DATE: August 5, 2014

SUBJECT: PUD 14-01 SUB 14-01, Cedar Brook PUD
Follow Up from Public Hearing on July 15, 2014

Engineering Department Land Use Application Review Comments

Project: Cedar Brook Planned Unit Development (PUD 14-01, SUB 14-01)

POST-DEVELOPED BASIN MAP

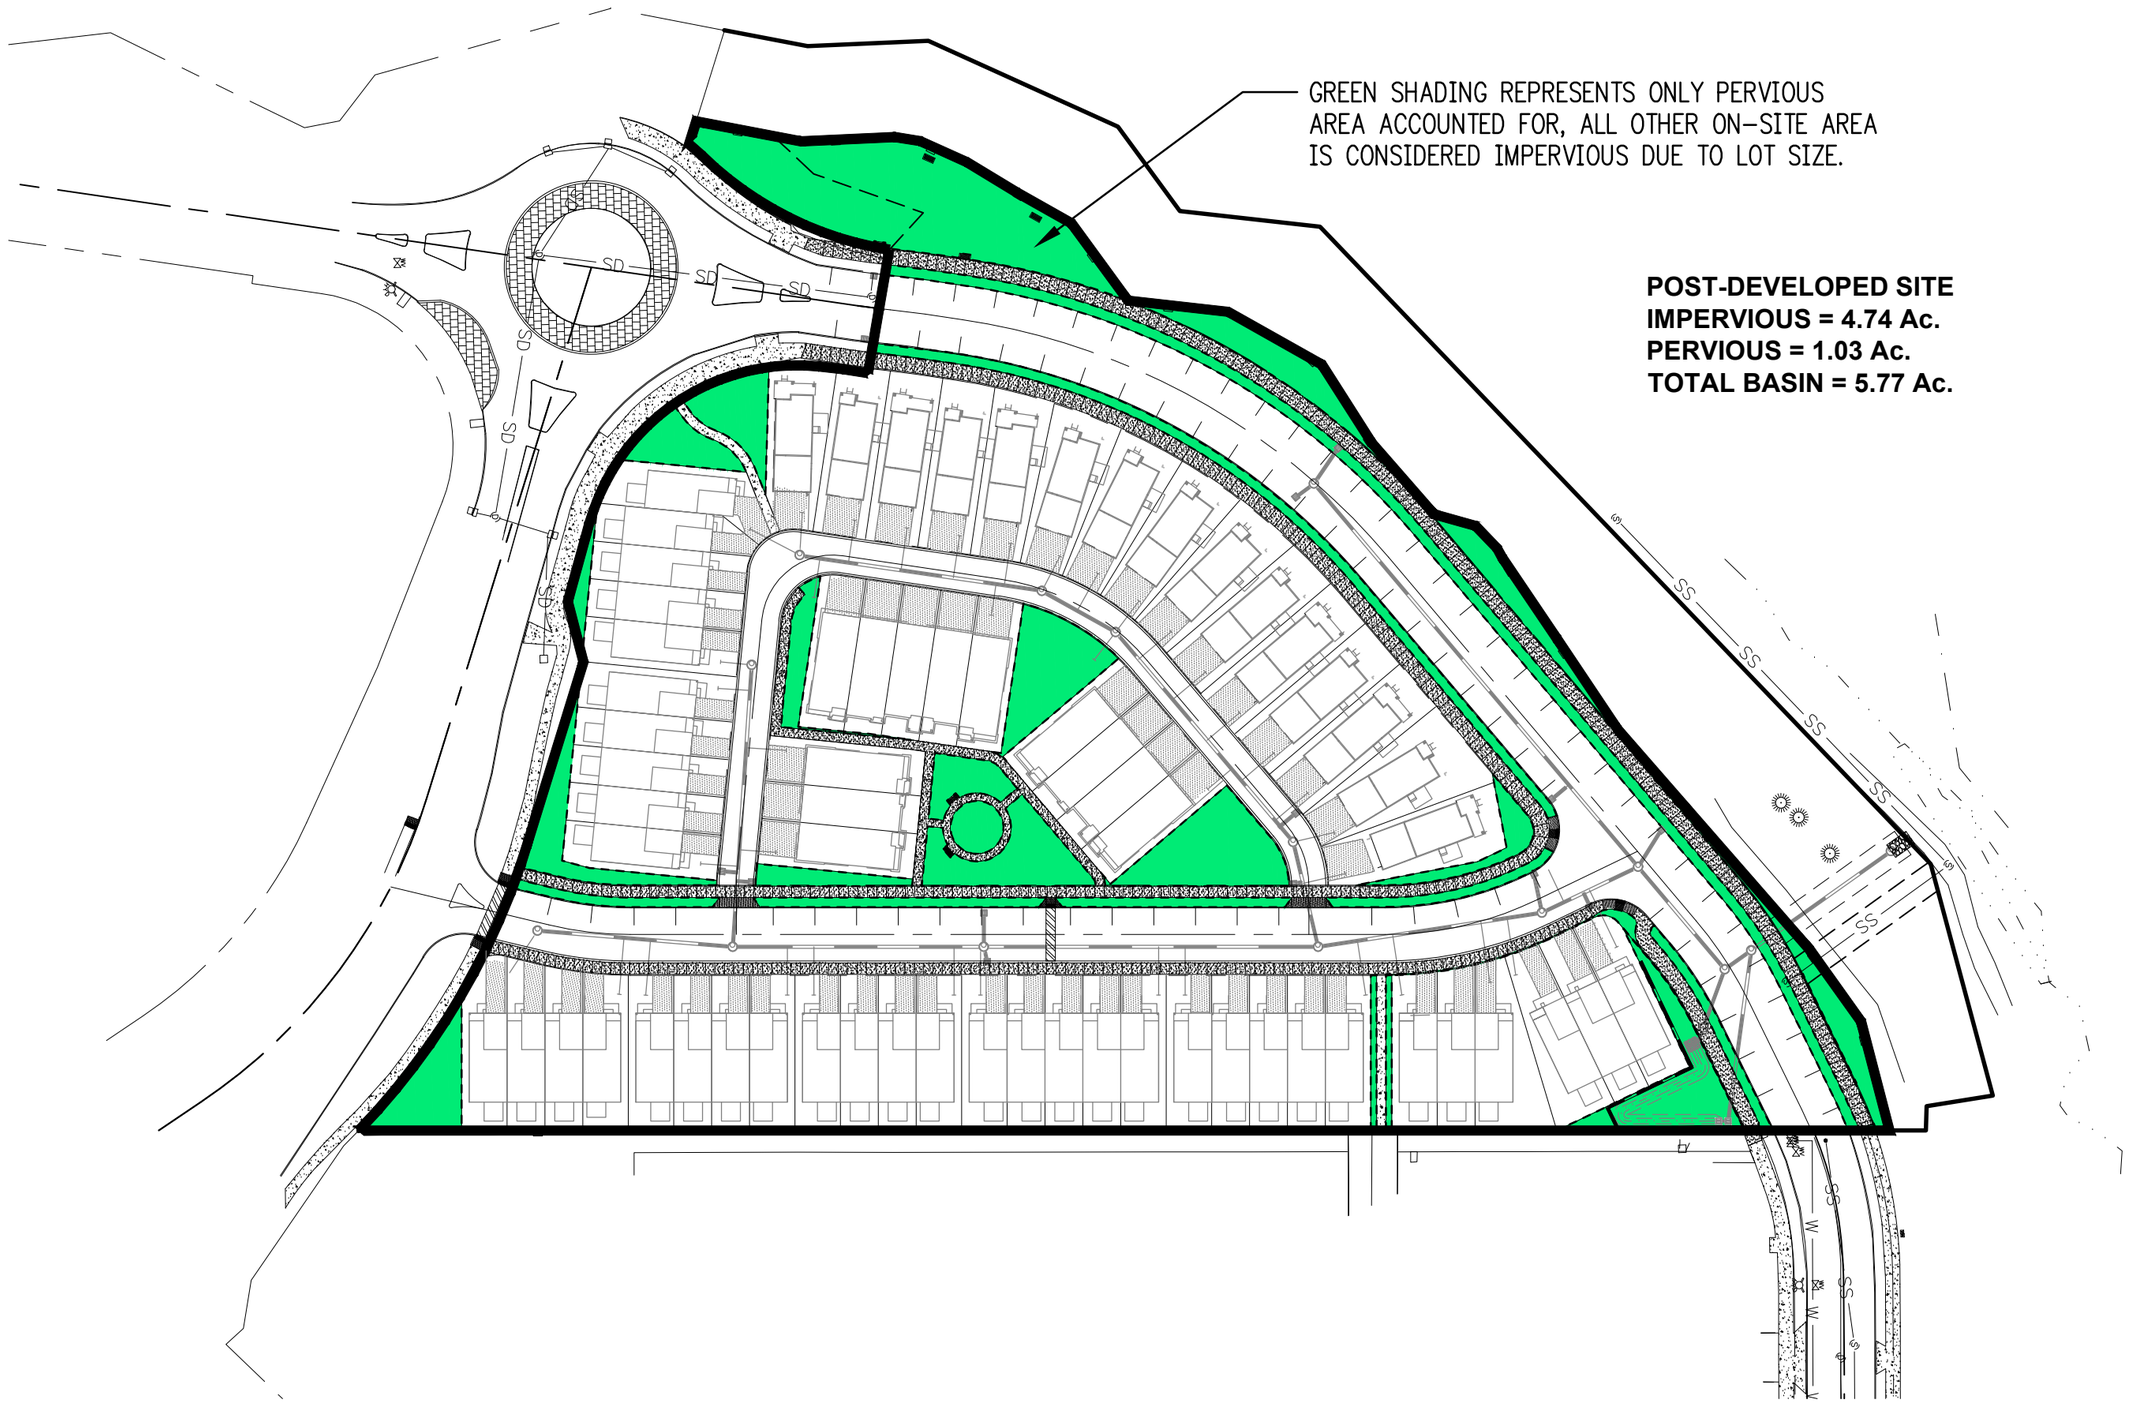
During the previous hearing, the applicant asked the City Engineer about treating and detaining their stormwater treatment facility on Tract C located in the northeastern corner of the site on the preliminary plat near proposed Lot 1 as opposed to the regional pond located further north and east near Cedar Brook Way. The amended proposal locates the storm water treatment facility on Tract C (Exhibit T.) The City Engineer has reviewed the proposal to determine whether it can feasibly serve the site and has provided a summary that is included in the Council materials. (Exhibit U.) Based on this review, Conditions D. 2 and D.12 of Exhibit 1, (Planning Commission Recommendation to Council) adequately addresses compliance with the City's standards and the CWS Service Provider Letter. Because the site will now serve as the water quality facility, staff recommends that Tract C be dedicated either to the City or that it include an easement over its entirety for the benefit of the CWS and the City. This would be an added condition E. 9 of Exhibit 1.

The applicant proposes that the open space area in Tract C be used exclusively to accommodate the water quality facility. The applicant intends that this tract will be dedicated to the City for the purpose of monitoring and maintaining the water quality facility. If used as the water quality facility, Tract C would no longer be included in the open space calculation. The applicant had intended that Tract C would be a landscaped area rather than useable open space like a park. Tract C is adjacent to the sidewalk on SW Cedar Brook Way, so it did not include any pedestrian pathways and the water quality facility will look similar to a landscaped area, except that the plantings will be serving the purpose of treating the storm water runoff.

The change results in a reduction of open space by 3,581 square feet or 2 percent of proposed overall open space on the site. The threshold for required open space is 15 % and if Tract C were used for water quality treatment, the applicant would have 19 % open space, therefore they would continue to be in compliance with the standard. The minimum residential density for the site is now 63 dwelling units and the applicant continues to meet this requirement by providing 65 dwelling units.

> ***E. 9. Prior to approval of the final plat, Tract C will either be dedicated to the City of Sherwood or have a public storm water facility easement be placed over the tract in its entirety for the benefit of CWS and the City. The subdivision plat shall note the dedication of Tract C to the City or include language establishing a Public Storm Water Facility Easement over Tract C for the benefit of CWS and the City.***

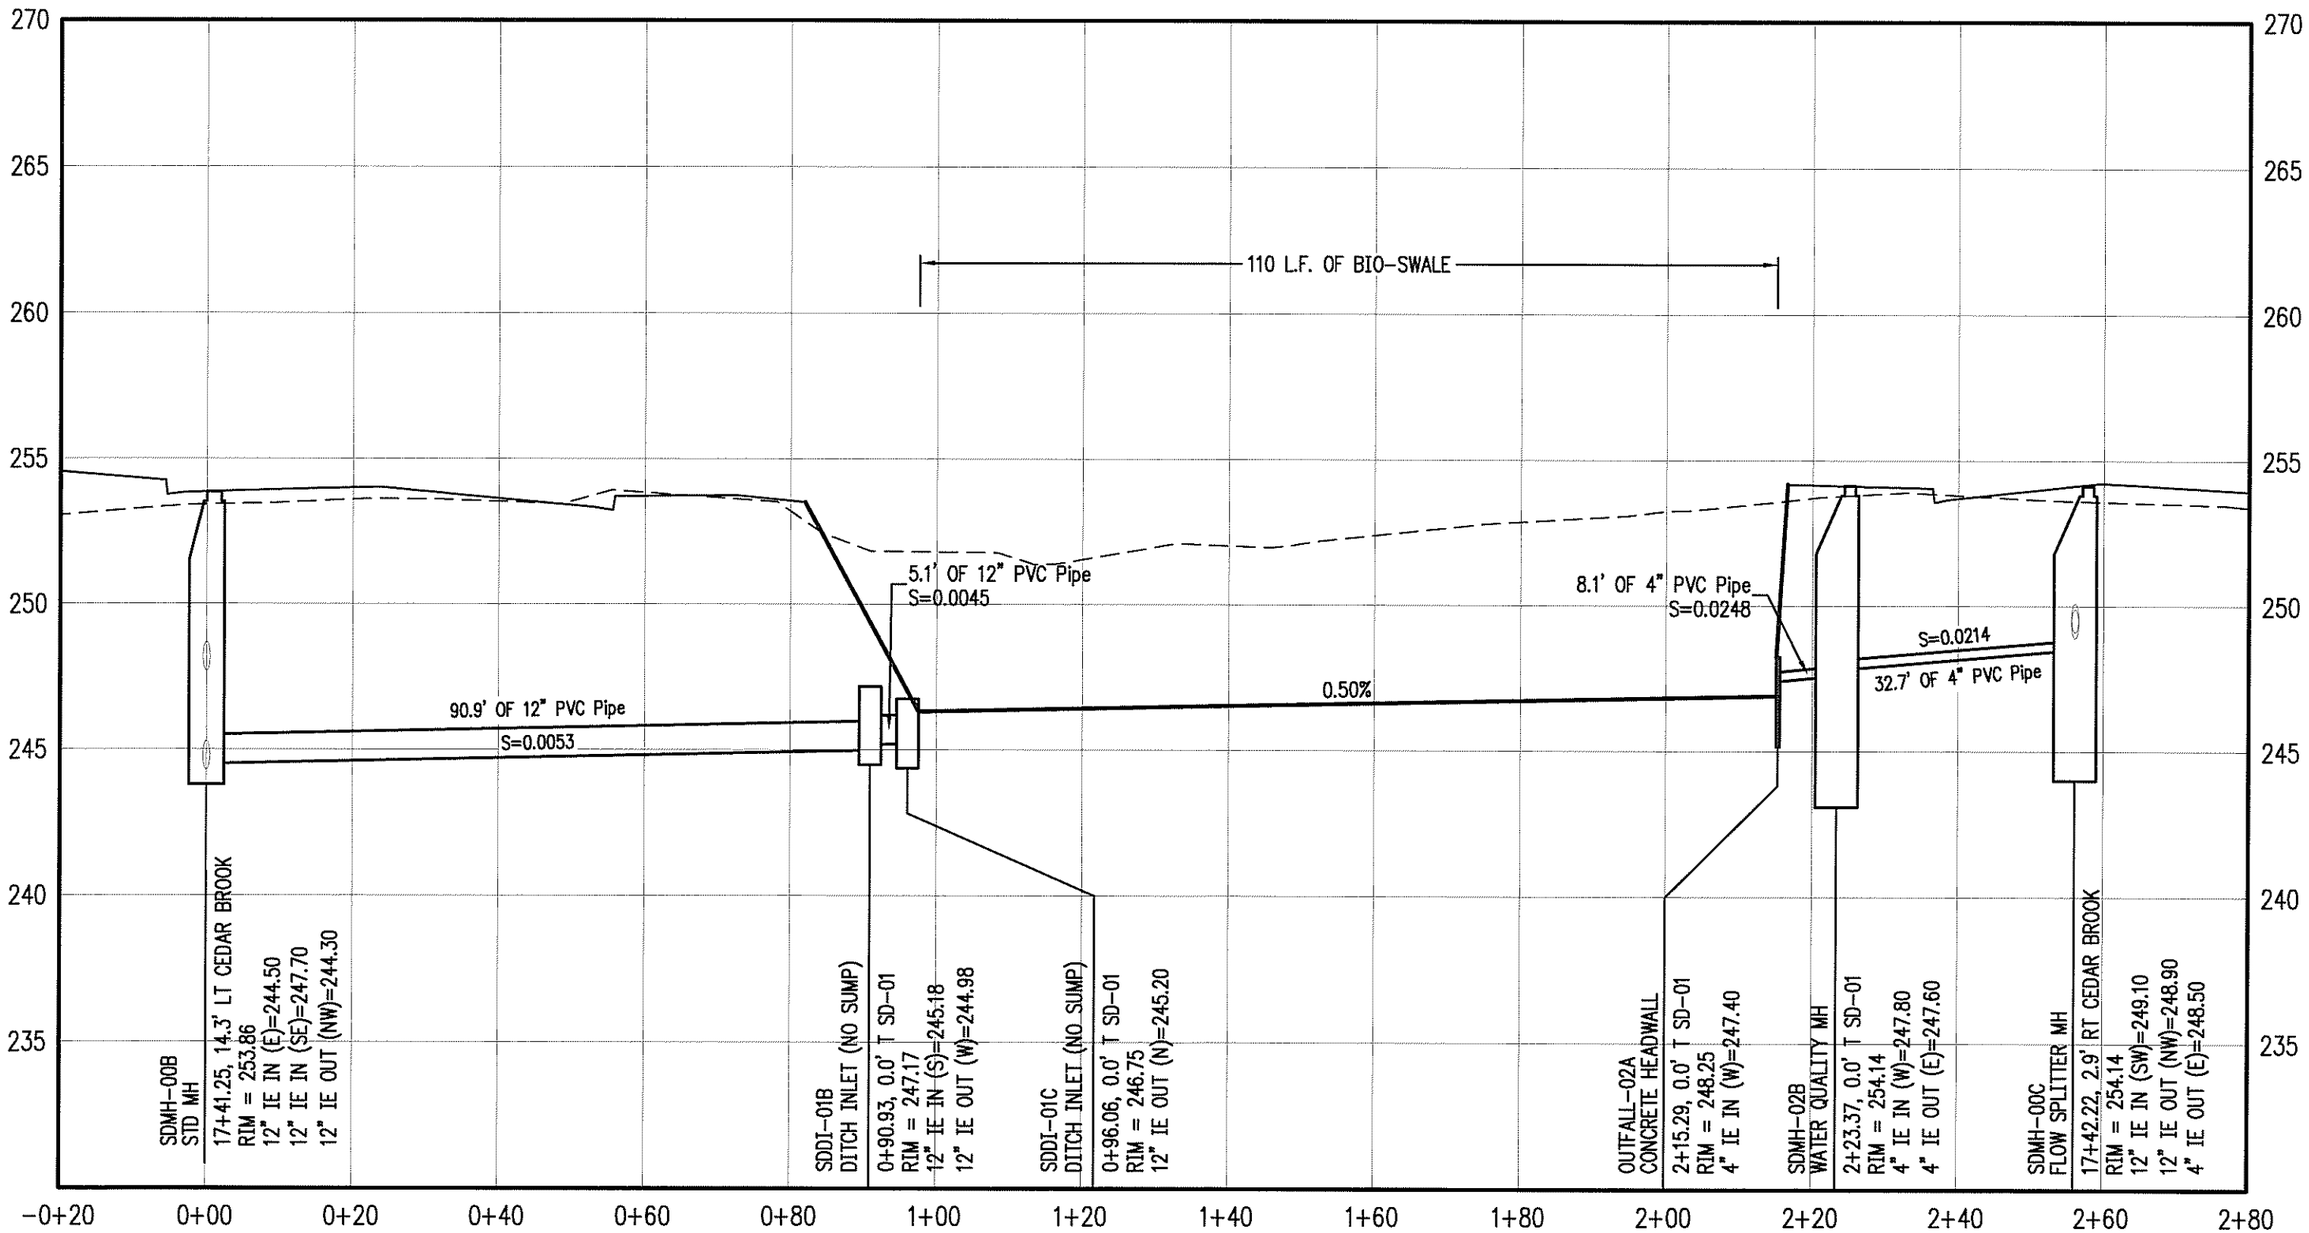
Just prior to the City Council meeting of July 15th, the applicant approached the City Engineer with preliminary information regarding a change of plan for providing storm water treatment. The information was provided verbally and with no supporting documentation. The information proposed utilizing Tract C, the small triangular portion of open space land, located at the north corner of the site adjacent to Cedar Brook Way.

The proposed change has merit in that the impact to the existing storm water system and public road infrastructure is eliminated. The issue is whether this change is acceptable to the City Council given the PC has not reviewed the proposal and has not been afforded the opportunity to provide comments or a recommendation.

1. The engineering calculations are predicated on meeting CWS design standards for the water quality storm event (2-yr/24-hour). Detention is not a CWS requirement so calculations for detention are not included.
2. The calculations provide the physical dimensions for the water treatment system. These physical dimensions also meet CWS requirements for a storm water treatment swale.
3. The schematic drawing(s) provide assurance that the storm water treatment swale is constructible and will be able to fit within the property line limits of Tract C. Certain design elements of the stormwater system will need some minor revisions, but these elements do not affect the initial opinion of constructability and fit.
